**17-21 ROTHERHITHE OLD ROAD
LONDON SE16**

NMA DRAWINGS COMPARISON DOCUMENT

PREPARED BY
GLAS ARCHITECTS & DESIGNERS
DOCUMENT: 329_NMA_240328

FOR
KMP (SURREY QUAYS 2) LTD

Proposed Basement Floor Plan

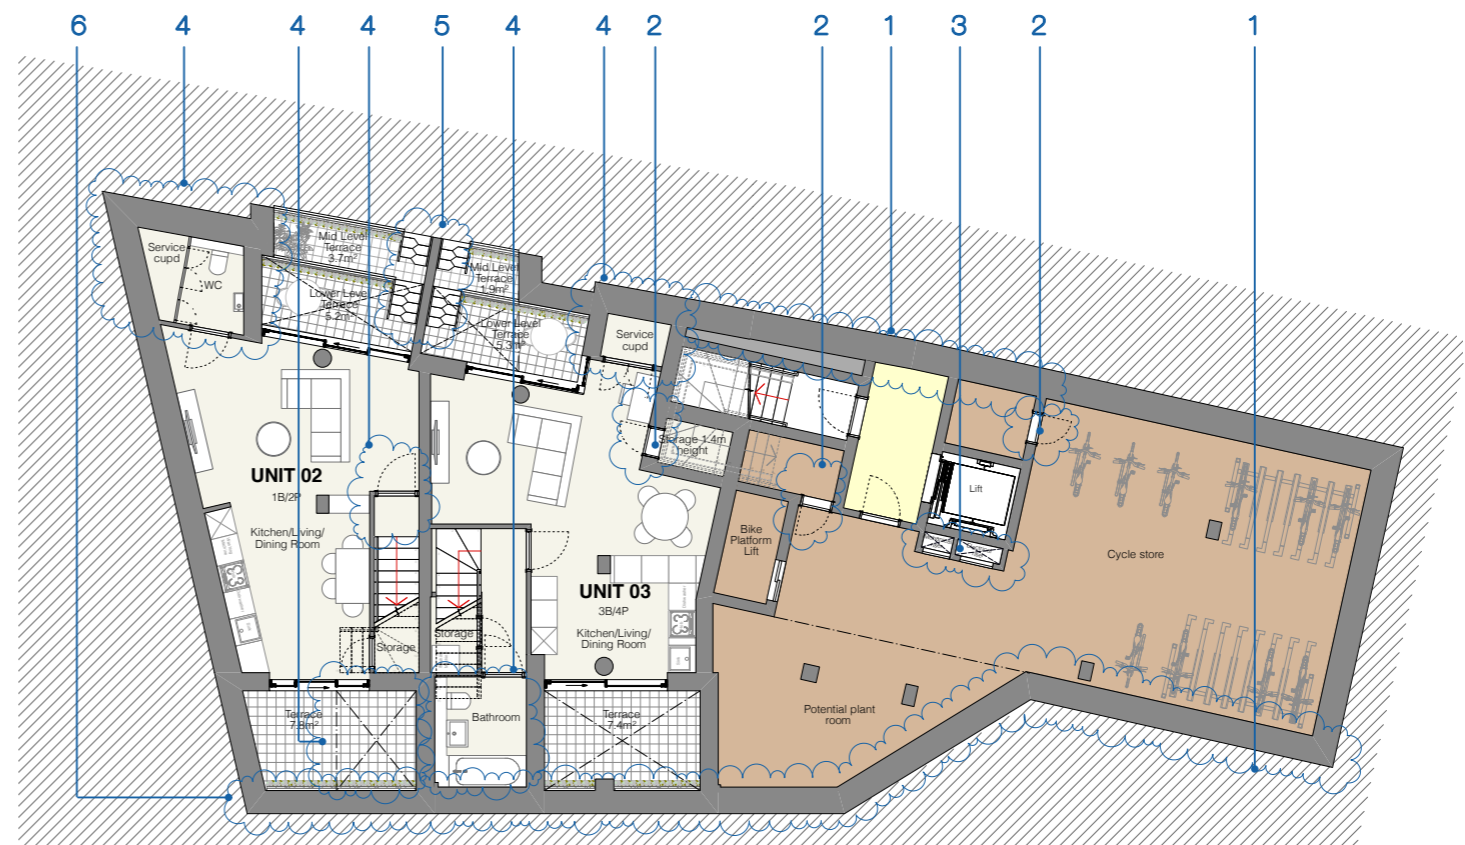
Highlighted in purple are the areas of adjustments and changes made to the planning approved scheme.

Proposed Amendments	
1	Rationalisation of basement - nominal increase in floor
2	Doors to plant room/store rooms amended
3	Proposed new mechanical/electrical riser to cycle store at basement level
4	Consolidation of storage and ancillary spaces
5	Tiering and extension of the external rear terraces, to include revised step access.
6	Enlargement of the external front terraces

Proposed Ground Floor Plan

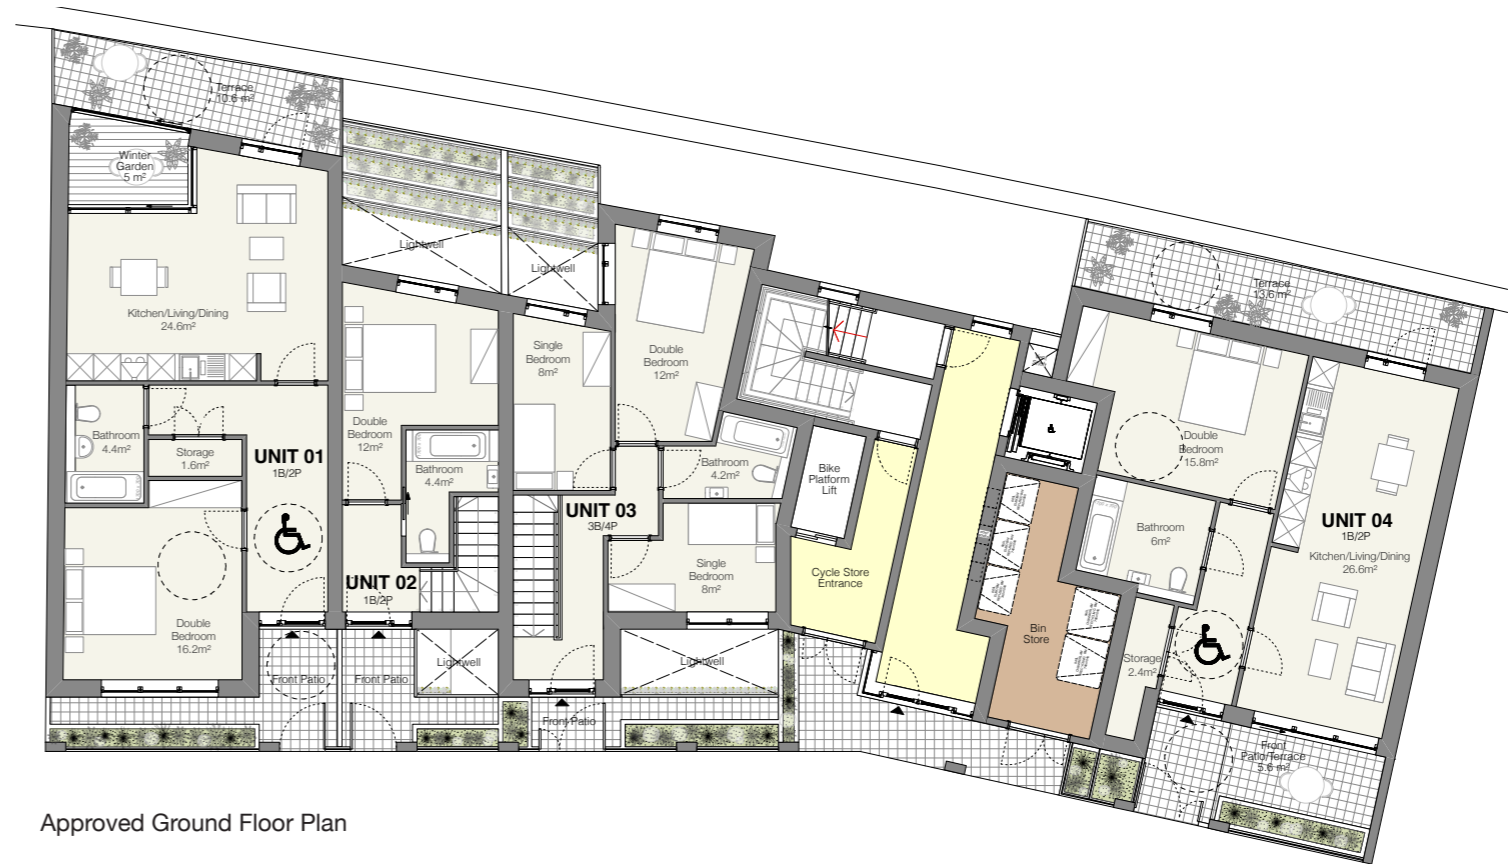
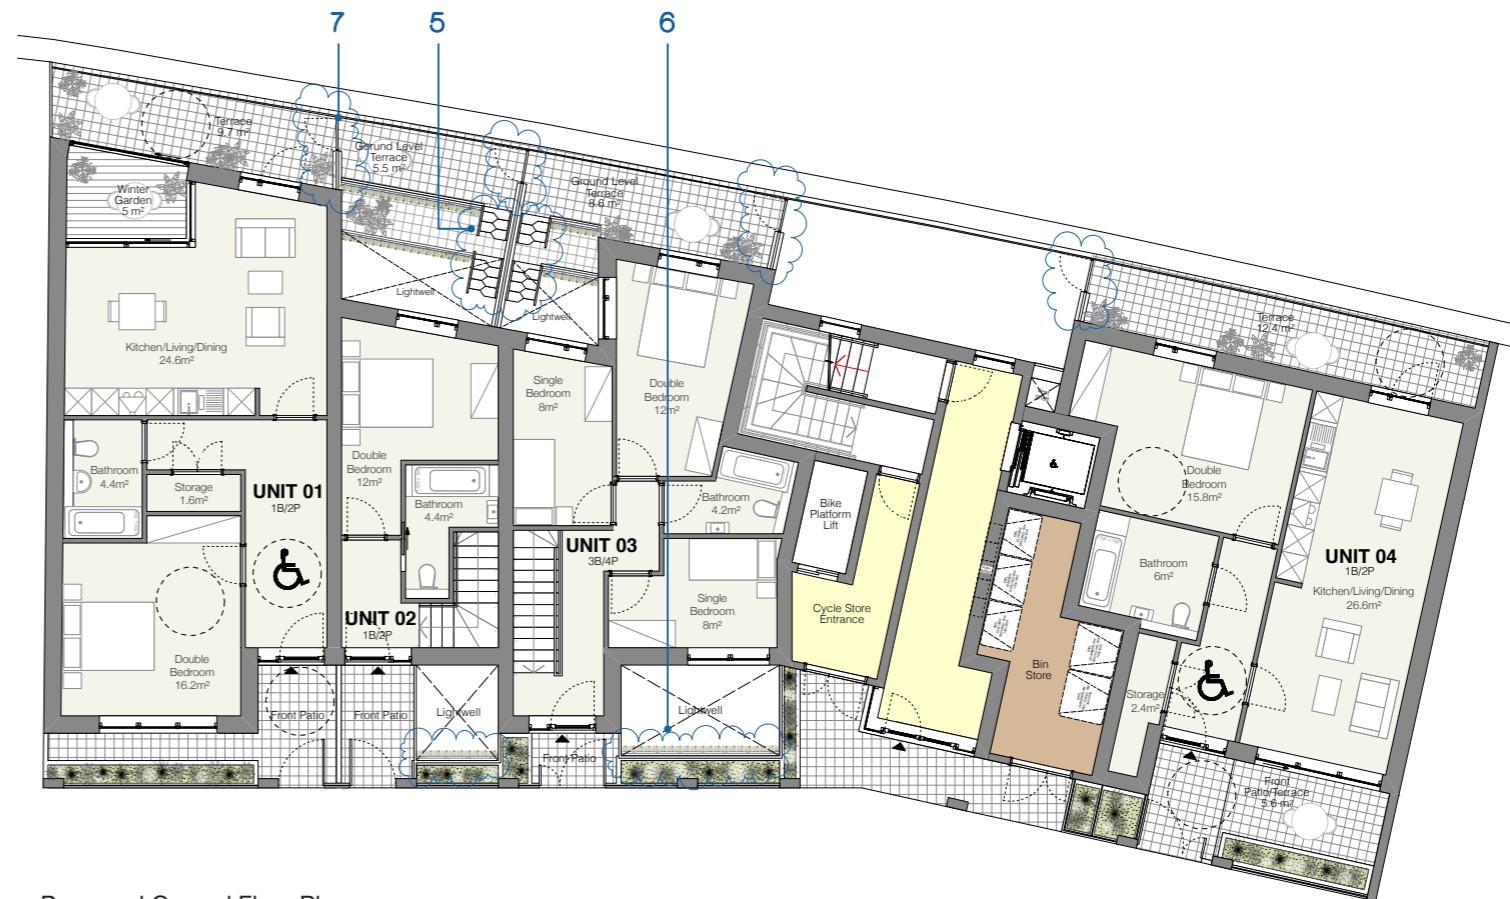
Proposed Amendments	
5	Tiering and extension of the external rear terraces, to include revised step access.
6	Enlargement of the external front terraces
7	Proposed new access to rear terraces at ground level; for maintenance purposes only and introduction of fencing.

Proposed Section A-A

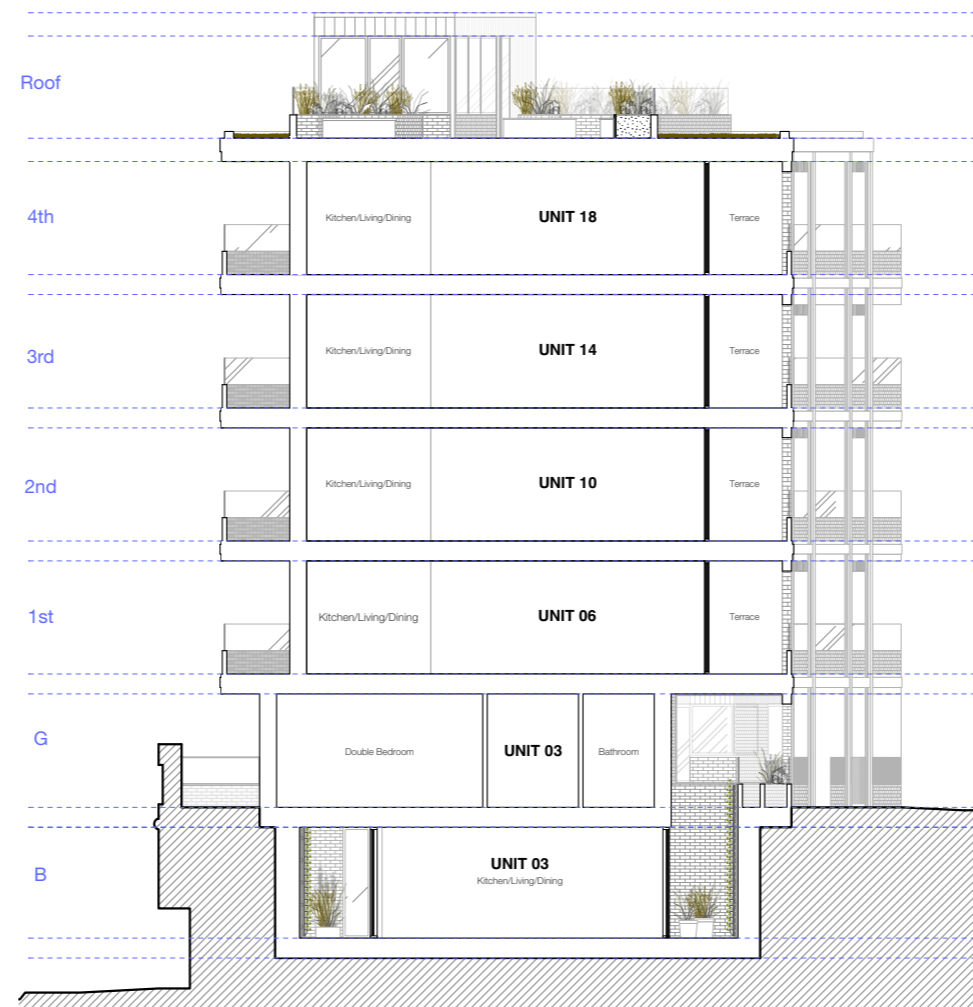
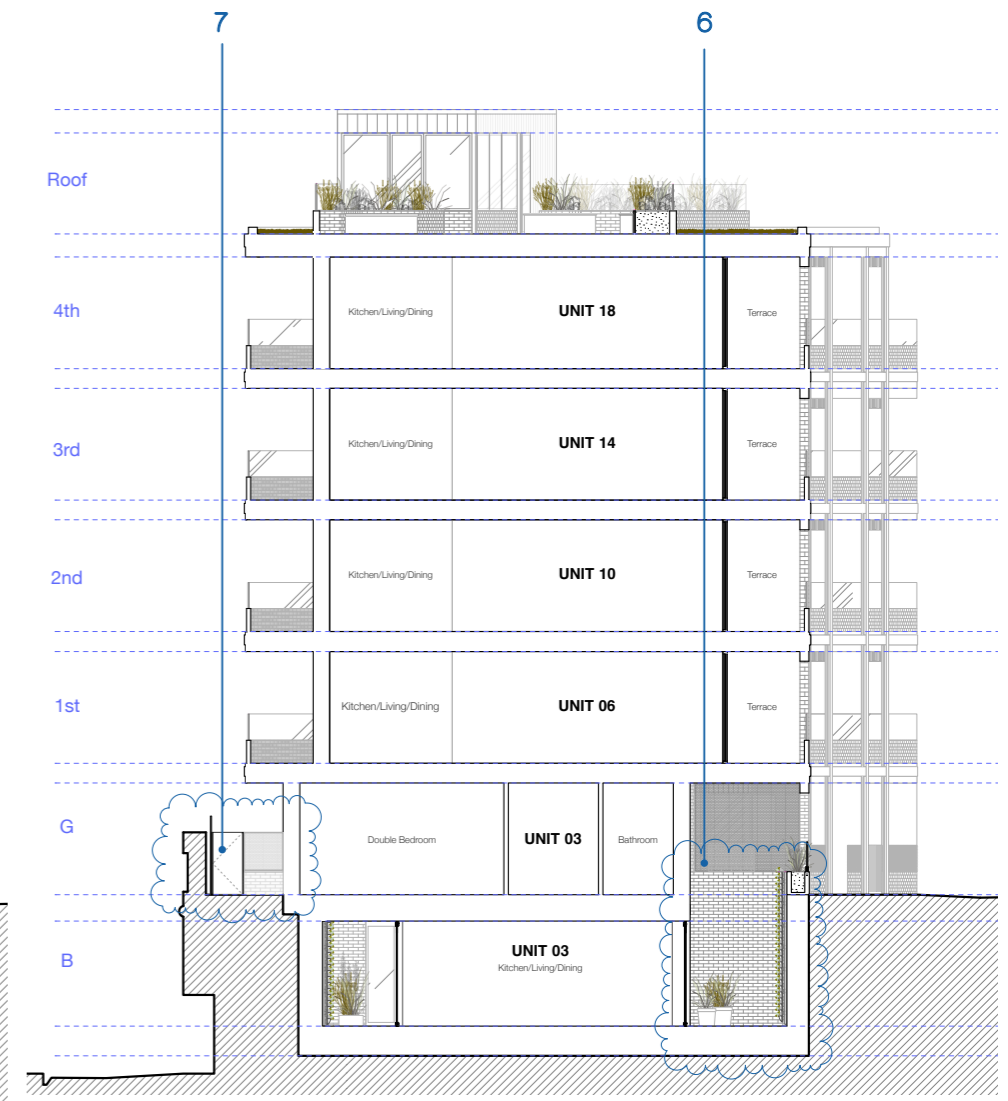
Proposed Amendments	
6	Enlargement of the external front terraces
7	Proposed new access to rear terraces at ground level; for maintenance purposes only and introduction of fencing.

Indicative Section C-C (as amended)

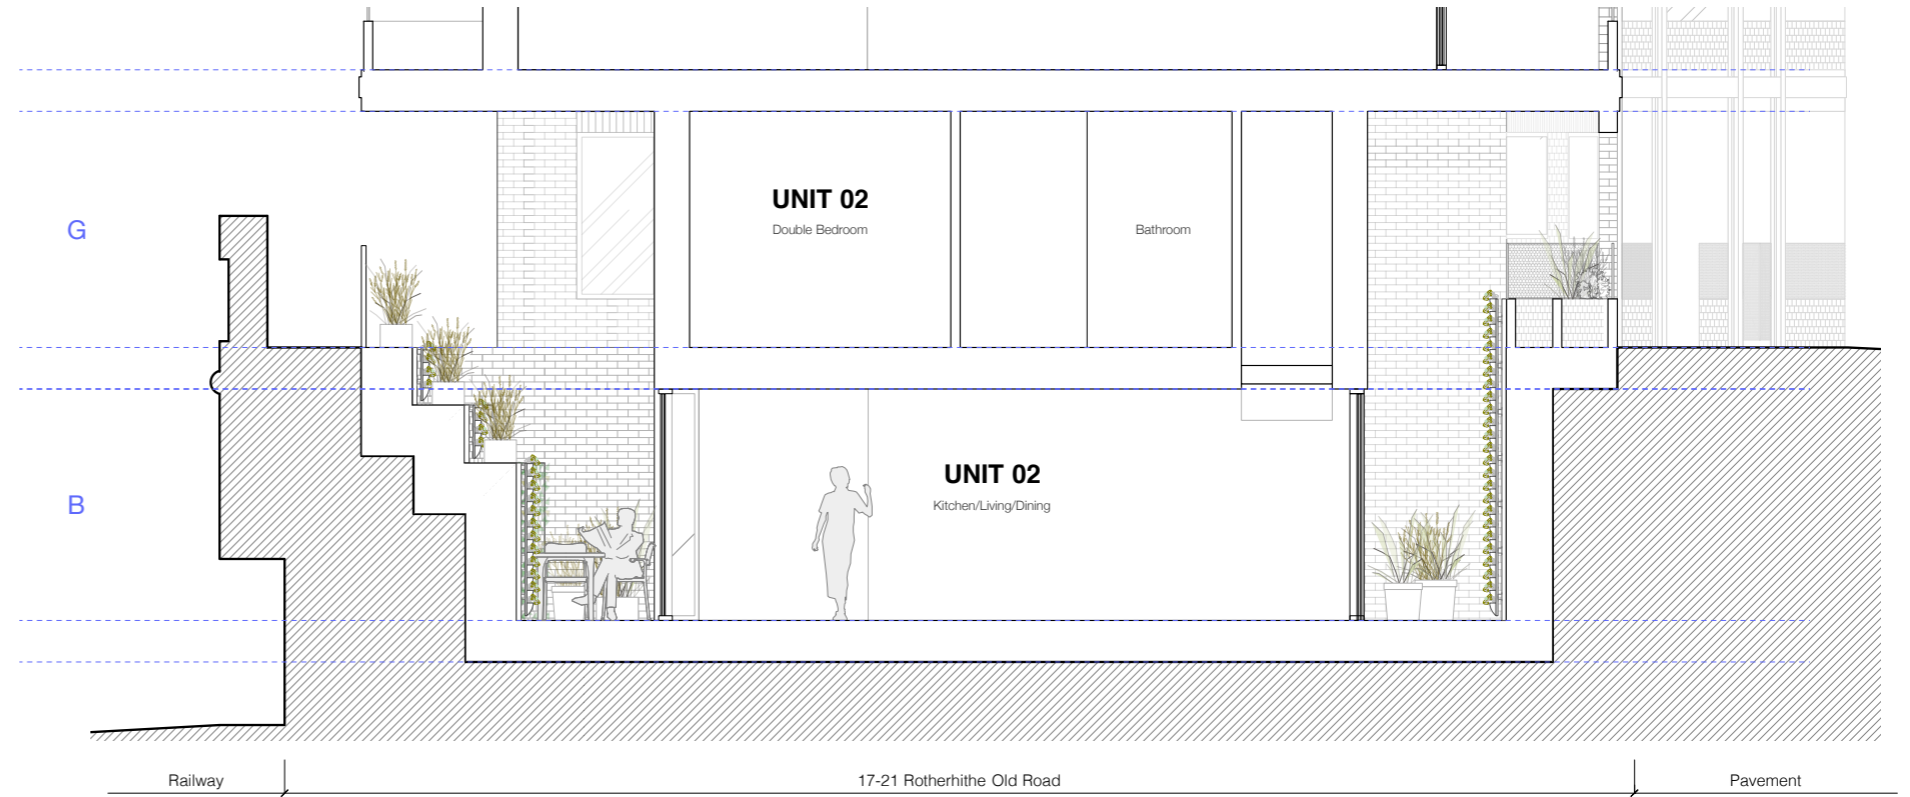
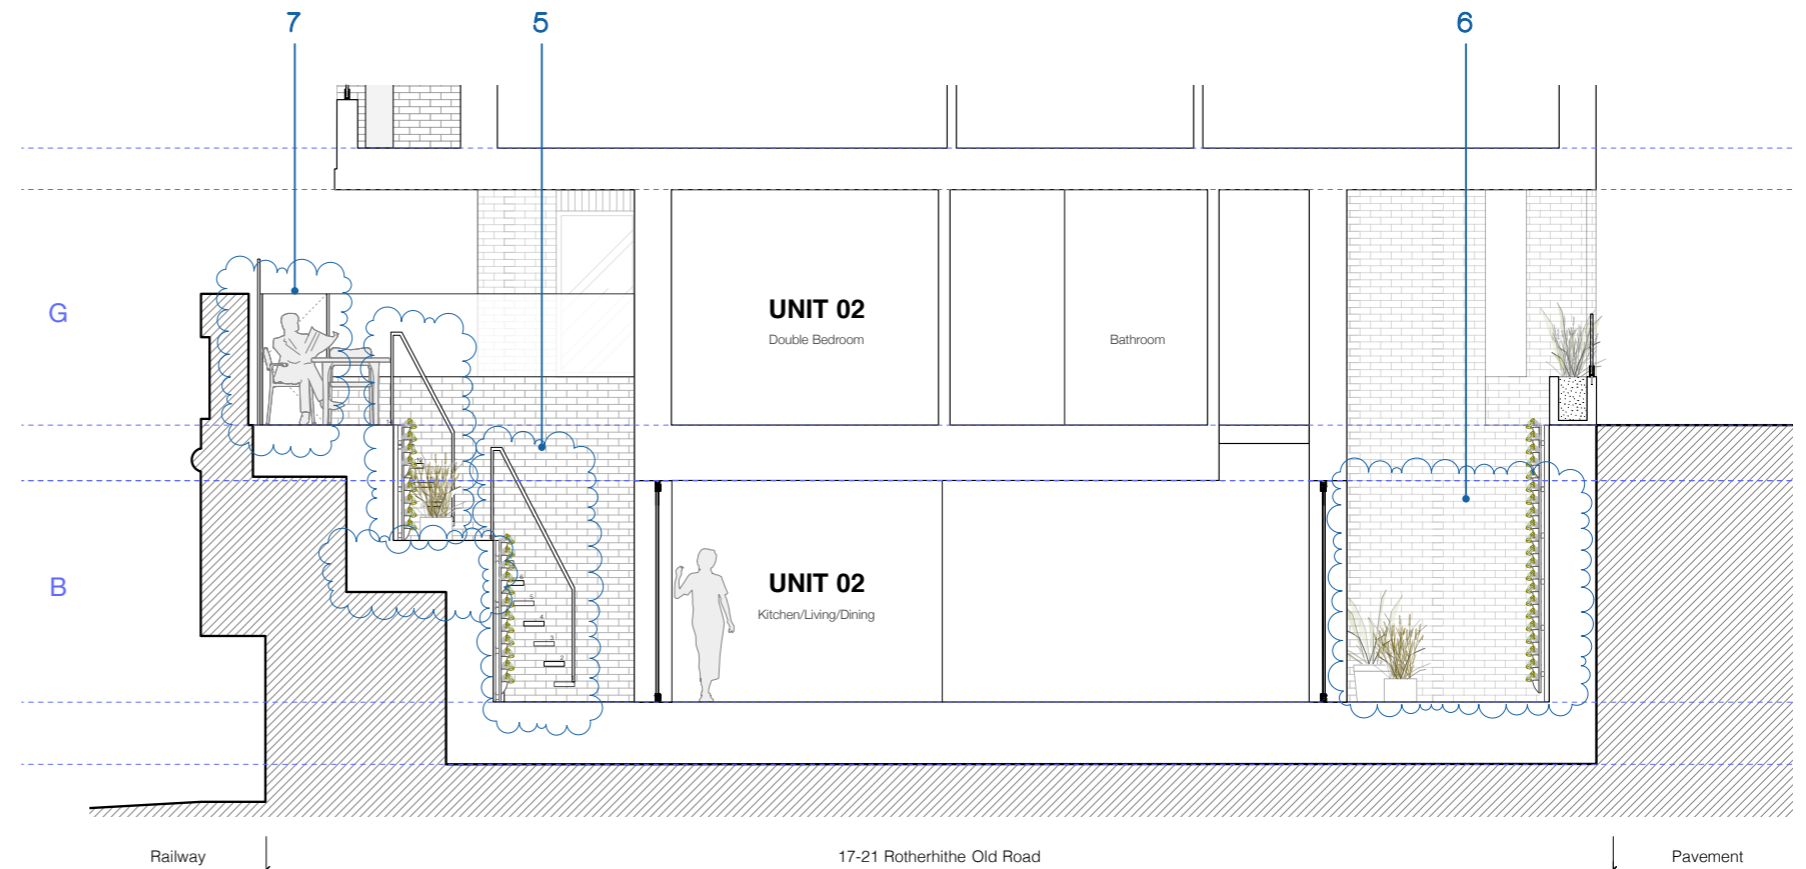
Proposed Amendments	
5	Tiering and extension of the external rear terraces, to include revised step access.
6	Enlargement of the external front terraces
7	Proposed new access to rear terraces at ground level; for maintenance purposes only and introduction of fencing.
